**WATERVLIET SHAKER ROAD (CR157) PHASE III ROADWAY
IMPROVEMENT PROJECT**

RFB-2022-105

ADDENDUM #2

AMENDMENT NO. 1 TO:
20-C558
Watervliet Shaker Road (CR 157) Roadway Improvement Project
IN THE LETTING OF
December 15, 2022

HYDRANT INSTALLATION DETAIL
NOT TO SCALE

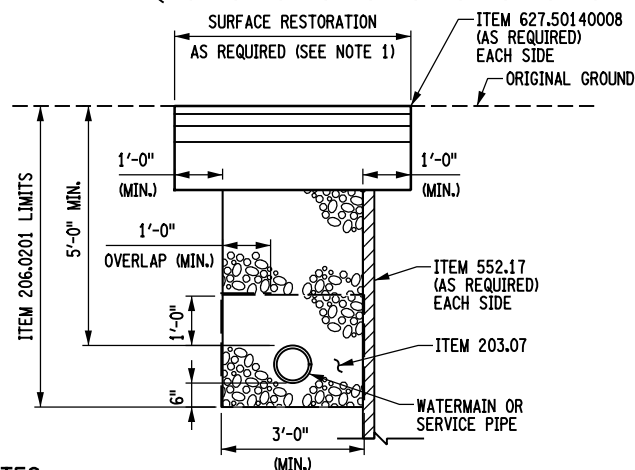
ITEM #1: Regarding the hydrant, are the bollards, valve and tee to be included in each item? Or are the valves, fittings and bollards paid under a separate item?

1. The following change has been made to Dwg. No. UTD-01 in the Contract Plans:

Notes have been added to clearly define how the hydrant installation is paid for. The detail has been updated to reflect the changes from the most recent version of the Latham Water District Standard Sheets.

1. Regarding the hydrant, are the bollards, valve, and tee to be included in each item? Or are the valves, fittings, and bollards paid under a separate item.

Response #1: The hydrant item, Item 663.1301, shall include all work required to install the hydrant as shown in the detail on Dwg. No. UTD-01, except for the valve/valve box and the 6" ductile iron pipe, which are paid for separately. The additional items shown on Utility Plan 7, DWG. UTP-07, have been put into the contract in the event that the valve is no longer functioning properly and needs to be replaced out to the main.

The bollards shall be included under Item 663.1301 Hydrant. The valves, water pipe, and fittings (if required) shall be paid for under their respective items. The detail on Dwg. No. UTD-01 has been updated to reflect this information.

- CONTRACTOR SHALL INSTALL NEW FIRE HYDRANT AND ASSOCIATED ANCHOR PIPE TO THE EXISTING WATER VALVE. IF IT IS FIELD DETERMINED THAT THE EXISTING VALVE CANNOT BE RE-USED, CONTRACTOR SHALL COORDINATE WITH THE LATHAM WATER DISTRICT FOR NOTICES AND REQUIREMENTS TO SHUT DOWN THE MAIN IF DEEMED NECESSARY.
- IF THE EXISTING WATER VALVE CANNOT BE RE-USED, A NEW VALVE AND VALVE BOX ASSEMBLY SHALL BE INSTALLED AND PAID SEPARATELY UNDER ITEMS 663.1206 AND 663.42.
- THE 6" DUCTILE IRON CEMENT LINED WATER PIPE WILL BE PAID SEPARATELY UNDER ITEM 663.0106. IT IS NOT ANTICIPATED THAT THE EXISTING ANCHORING TEE AT THE MAIN WILL NEED TO BE REPLACED. ALL OTHER ITEMS AND WORK REQUIRED TO INSTALL THE NEW HYDRANT PER LATHAM WATER DISTRICT STANDARDS SHALL BE INCLUDED UNDER ITEM 663.1301.
- DISTANCES GREATER THAN 10'-0" MUST BE APPROVED BY THE SUPERINTENDENT OF THE LATHAM WATER DISTRICT.

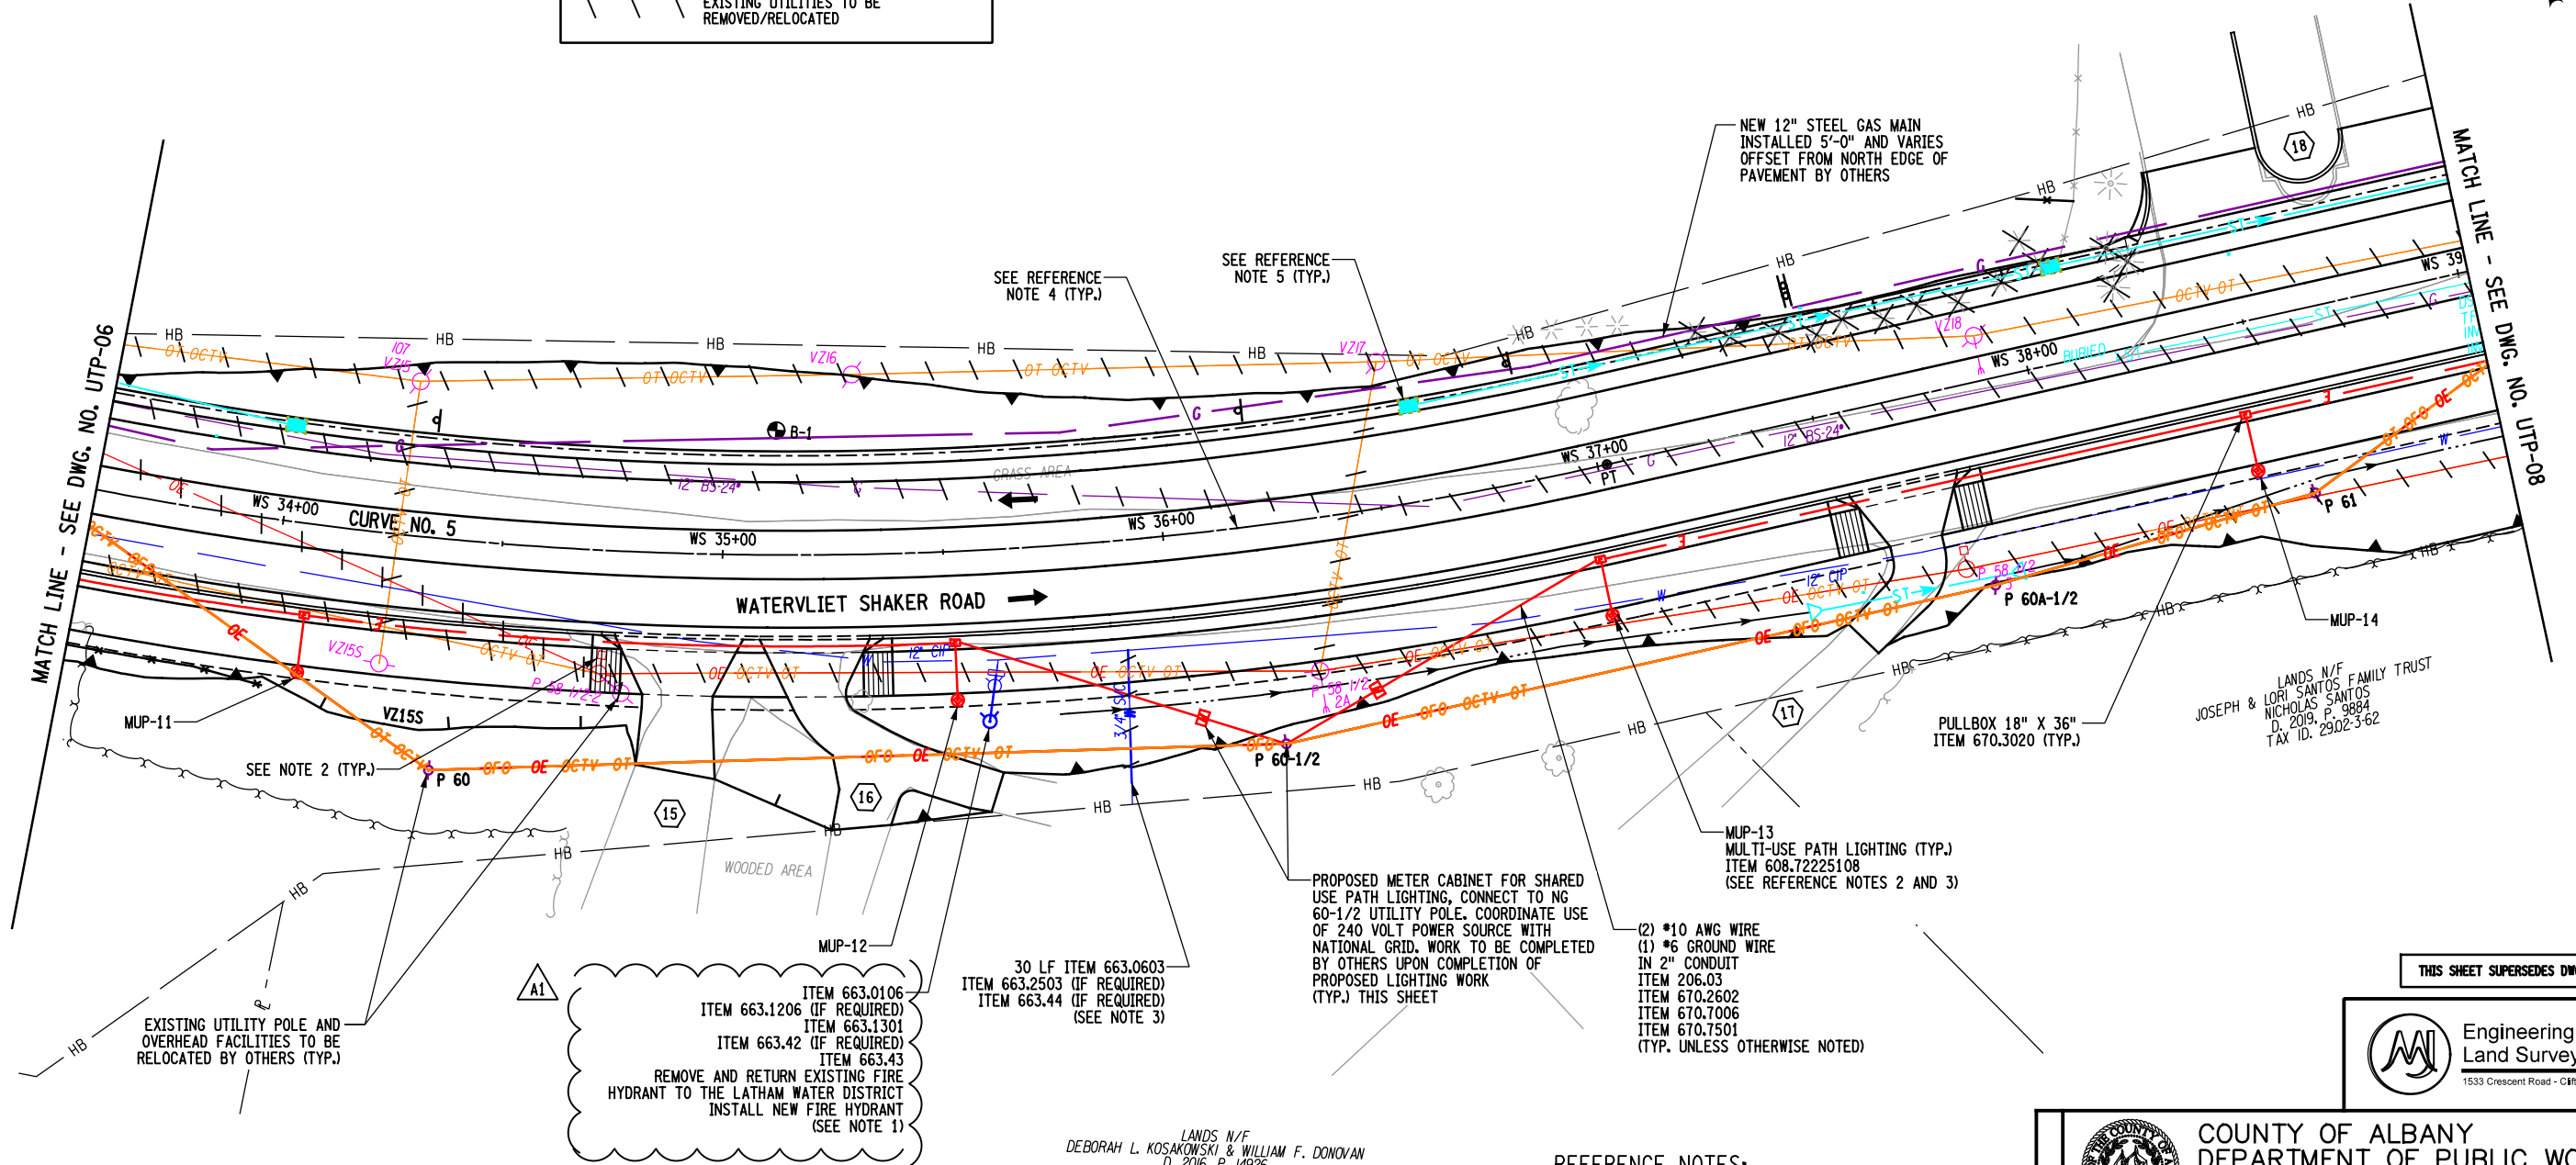
2. The following change has been made to Dwg. No. UTP-07 in the Contract Plans:

"(IF REQUIRED)" has been removed from the callout after "ITEM 663.0106".

- CONTRACTOR SHALL INSTALL NEW FIRE HYDRANT AND ASSOCIATED ANCHOR PIPE TO THE EXISTING WATER VALVE. IF IT IS FIELD DETERMINED THAT THE EXISTING VALVE CAN NOT BE RE-USED CONTRACTOR SHALL REPLACE THE VALVE AND ANCHOR PIPE TO THE TEE AT THE MAIN. CONTRACTOR SHALL COORDINATE WITH THE LATHAM WATER DISTRICT FOR NOTICES AND REQUIREMENTS TO SHUT DOWN THE MAIN IF DEEMED NECESSARY.
- THE EXISTING LIGHT FIXTURES ON UTILITY POLES TO BE RELOCATED SHALL BE RETURNED TO THE TOWN OF COLONIE.
- THIS RELOCATION IS REQUIRED TO ENSURE THAT THE SERVICE LINE IS NO LESS THAN 5' BELOW THE PROPOSED SURFACE ELEVATION.
